ADDENDUM #1 – APRIL 15, 2024

RE: SOUTH COAST EDUCATIONAL SERVICE DISTRICT
Attic Restoration
Project #23.61.2

FROM: HGE ARCHITECTS, Inc.
333 South 4th Street
Coos Bay, Oregon 97420
541-269-1166

1 FIRST FLOOR RCP
3/32" = 1'-0"

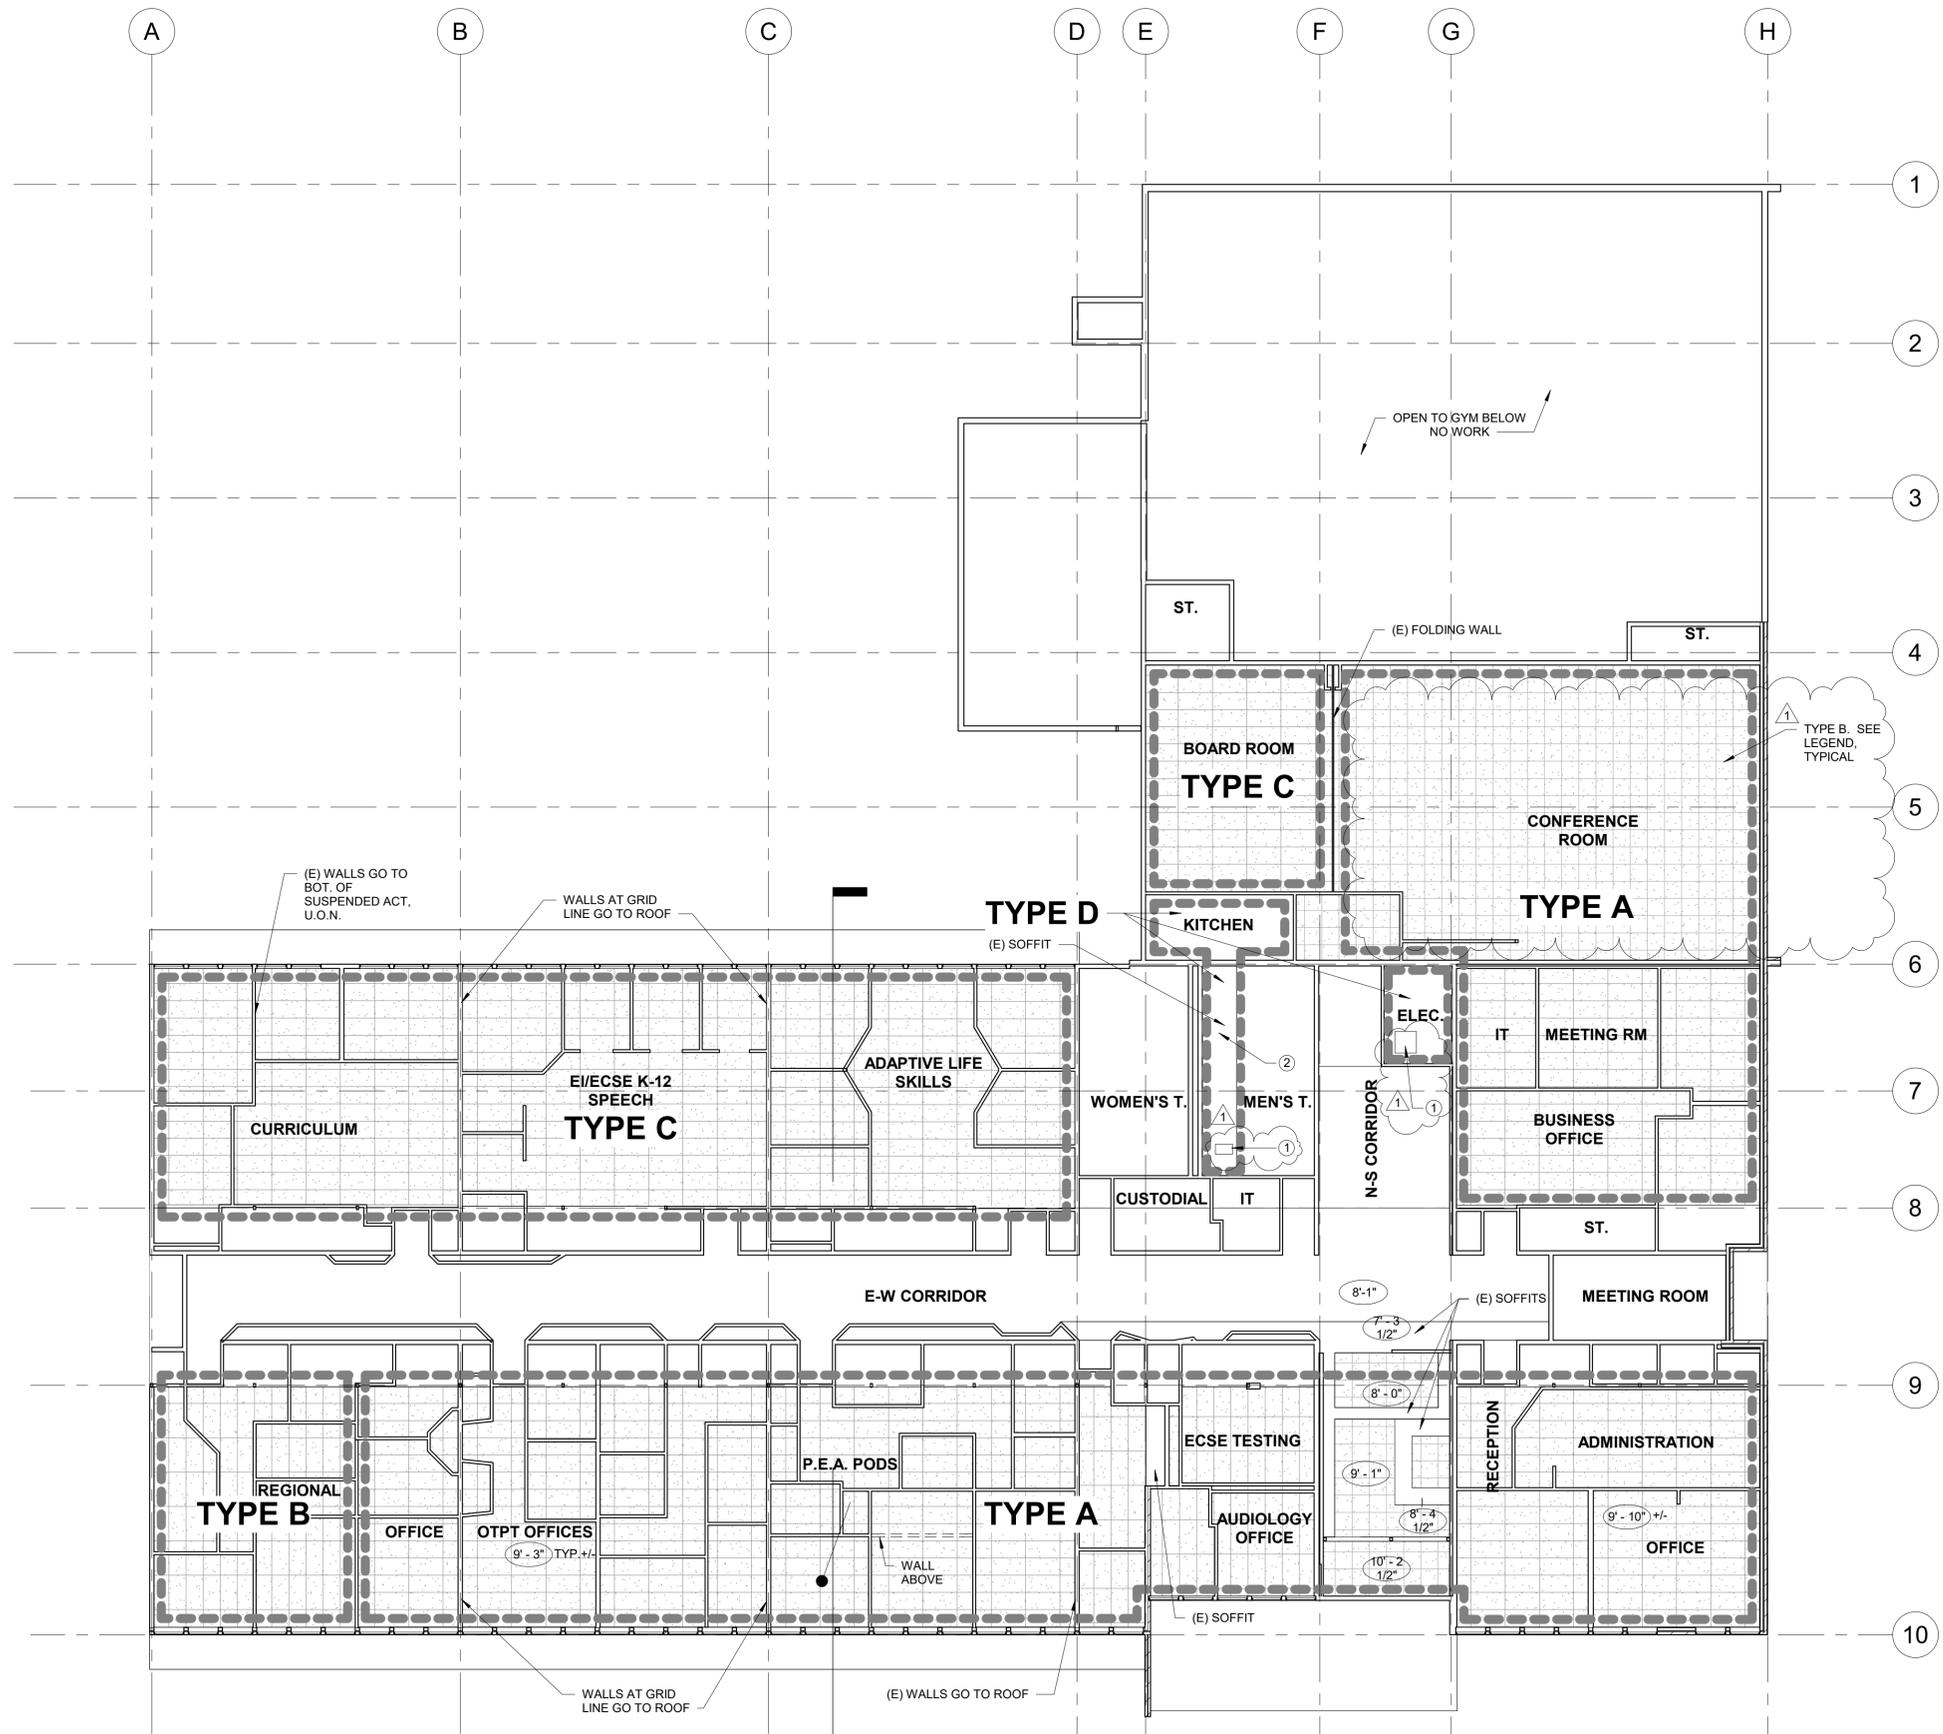
1. **Sheet A2.2 First Floor Reflected Ceiling Plan:** REPLACE with attached REVISED sheet. Summary of changes:
 - a. ADD to RCP Notes: “D. THERE IS APPROXIMATELY 11,500 SF OF ACOUSTICAL CEILING TILE (ACT) IN THE PROJECT
 - b. ADD to the RCP Legend “TYPE A” and “TYPE B” to the ACT type descriptions respectively.
 - c. REPLACE 2X4 ACT graphic in the Conference Room, with 2X2 ACT Grid.
 - d. ADD Access Panel and Key Note #1 to Men’s Toilet.
 - e. ADD Access Panel to the Electrical Room

RCP LEGEND NOTE: ACT SHOWN FOR MATERIAL ONLY, NOT DIRECTION OF ACT GRID

TYPE A: (E) SUSPENDED "SECOND LOOK" 2 X 4 ACT (ACOUSTICAL CEILING TILE). SEE CEILING SCHEDULE FOR ADDITIONAL INFO.

TYPE B: (E) SUSPENDED 2 X 2 ACT (ACOUSTICAL CEILING TILE). SEE CEILING SCHEDULE FOR ADDITIONAL INFO.

- RCP NOTES**
- A. LIGHTS NOT SHOWN. REMOVE LIGHT FIXTURES IF REQUIRED AND RETURN TO EXISTING LOCATIONS
 - B. INSPECT TOPS OF EXISTING GYP. BOARD FOR DAMAGE FROM RODENTS
 - C. PROTECT EXISTING BUILDING, MATERIALS, UTILITIES, FIXTURES AND ALL OTHER ELEMENTS THAT ARE TO REMAIN
 - D. THERE IS APPROXIMATELY 11,500 SF OF ACOUSTICAL CEILING TILE (ACT) IN THE PROJECT
